La Marzocco Technical Bulletin #103

Pump Cable with Waterproof Connector

View of the connectors (Fig.1)

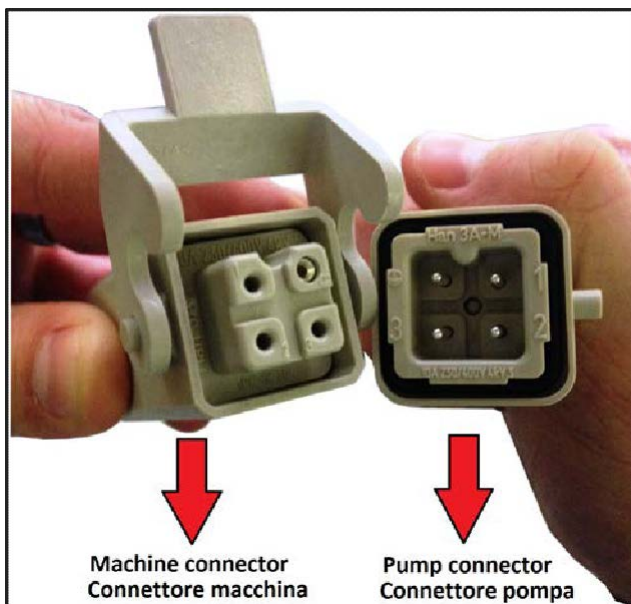
We would like to inform of the new pump cord connector E.4.044. This improvement will guarantee an easier and faster installation of the machine or pump motor replacement. Below is a quick instruction guide related to the quick connection between the water pump and the espresso coffee machine:

Connection nr. 1 - LINE / FASE Connection nr.2 - NEUTRAL / FASE Connection nr.3 - EMPTY / VUOTO
Earth Connection - EARTH / TERRA
